HCCSC Administration Building Renovation

Project # 2024.0001

ADDENDUM NO. A-1

EXHIBIT A-01: CORNER GUARD AND ACROVYN LOCATIONS REFERENCE PLAN

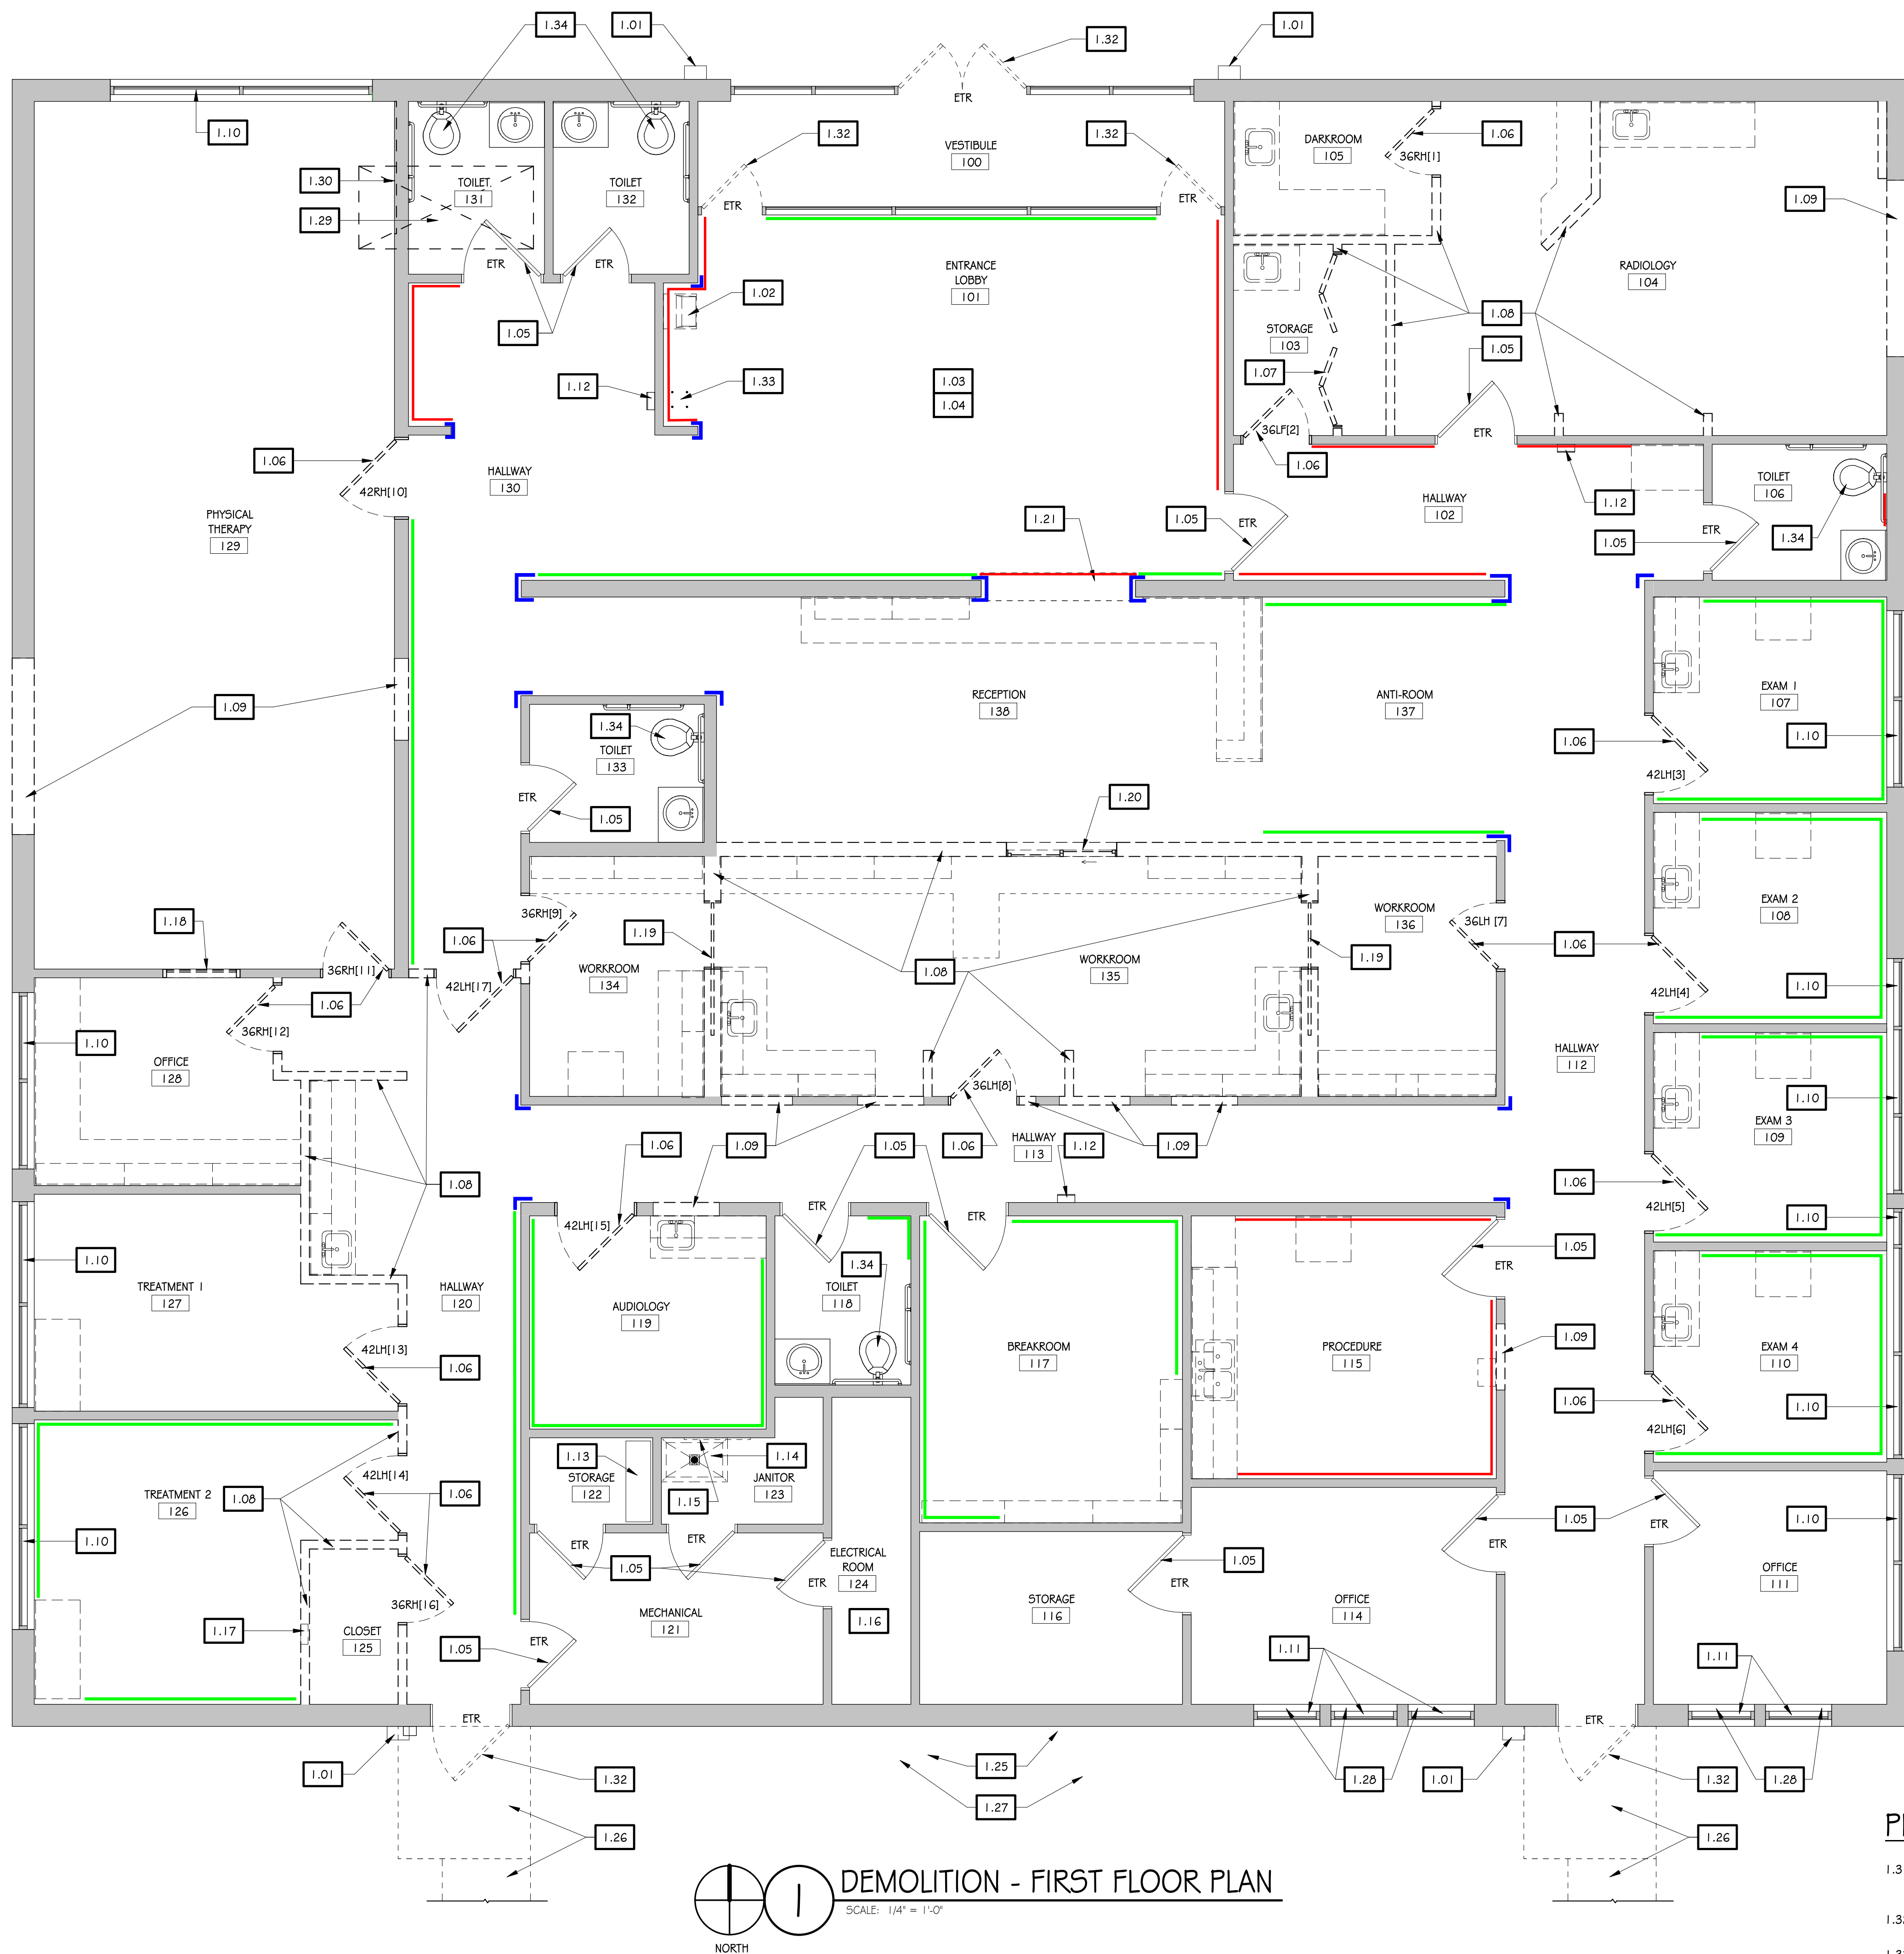
Item	A-1.15
Location:	Drawings Sheet D1.1, Plan Demolition Note 1.04.
Description:	Amend note to read, "CONTRACTOR TO REMOVE ALL WALL MOUNTED ACROVYN PANELS TYPICAL THROUGHOUT THE BUILDING, INCLUDING CORNER GUARDS. CONTRACTOR SHALL EITHER SKIM COAT WALLS AND PREPARE WALL PATCH TO RECEIVE NEW FINISH, OR CUT OUT AND REPLACE SECTIONS OF GYPSUM BOARD, MUD AND TAPE AND PREPARE WALL PATCH WALL TO RECEIVE NEW FINISH." See attached EXHIBIT A-01, reference plan for existing corner guard and Acrovyn locations.
